NUMBER 123

SUBJECT: Front Spar Interference

MODELS AFFECTED: All PA-20 and PA-22 Model Aircraft

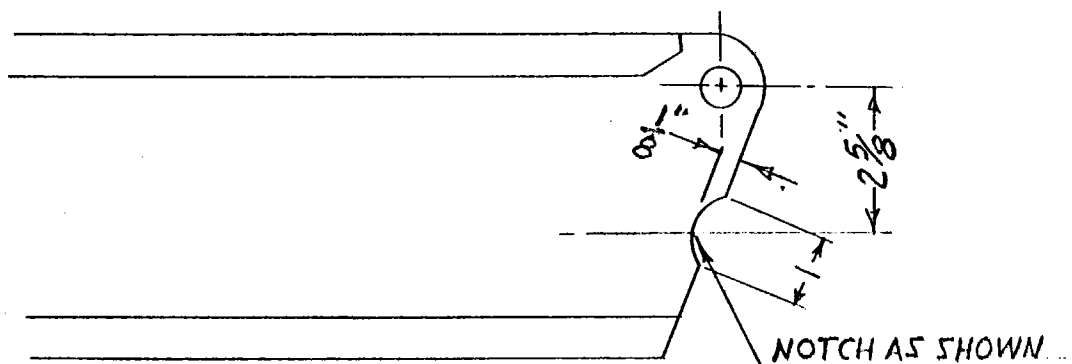
It is requested that an inspection be made to determine whether or not there is interference between the inboard end of the front spar web and the aileron pulley attachment bolt in the area of the front wing hinge fitting.

If there is less than one-eighth inch clearance between these two points, then the spar web should be filed out and sanded smooth in accordance with the following sketch:
